# AIR CONDITIONER

## ■ DESCRIPTION

### 1. Heater Control Panel

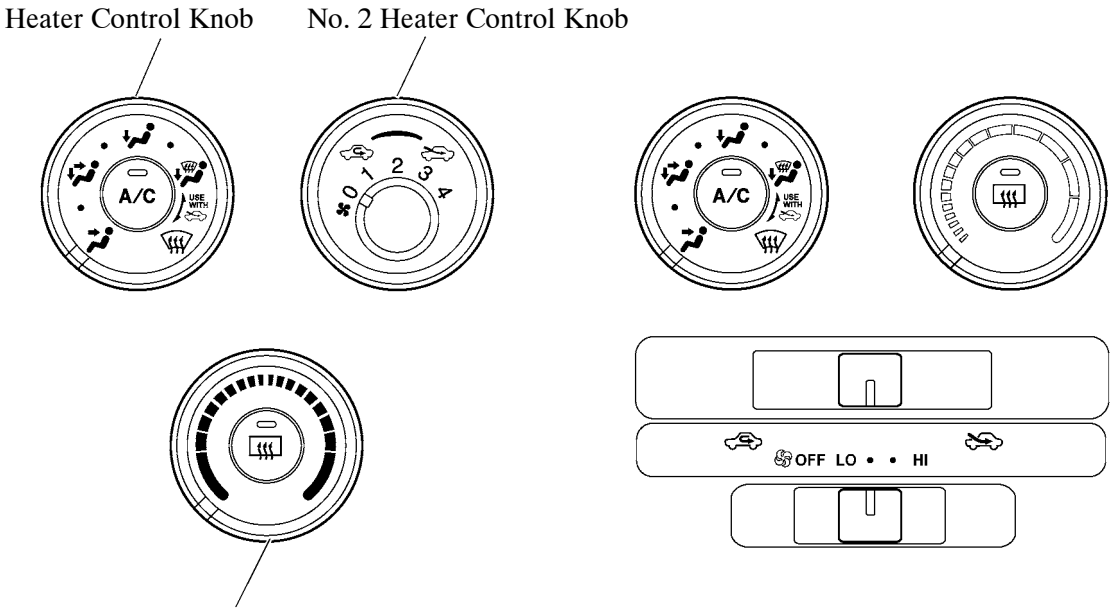
The design of the heater control panel has been changed. A dial (No. 2 heater control knob) which is integrated with internal/external air selector and blower controller has been adopted to improve operability and appearance.

**▶ Layout of Switch ◀**

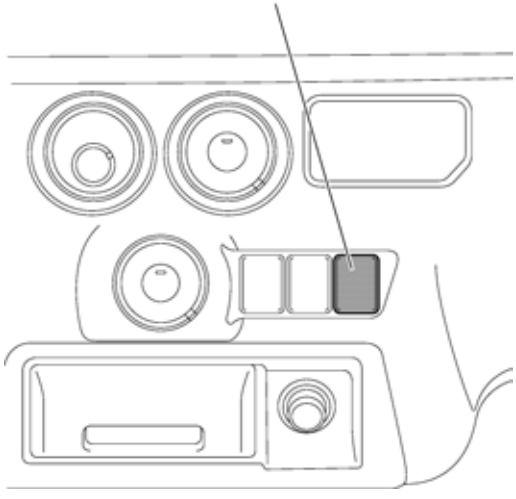
The design and shape of the heater switch assembly for the hot-gas power heater system have been changed.

**▶ Layout of Switch ◀**

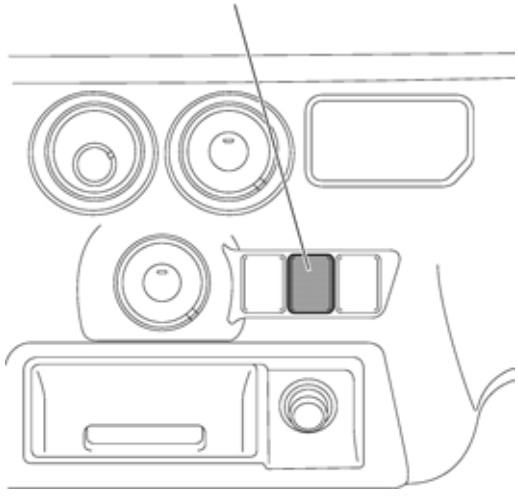
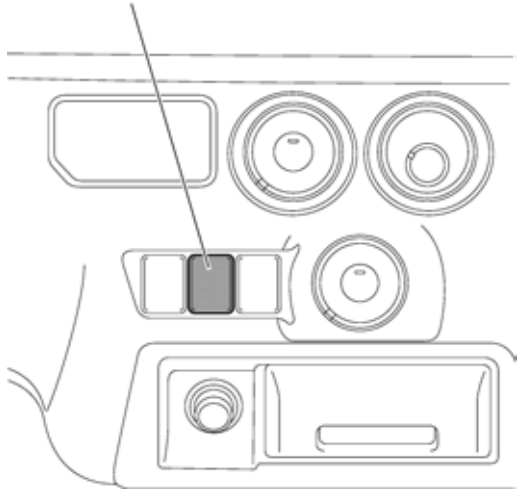
The design and shape of the heater blower switch assembly have been changed.
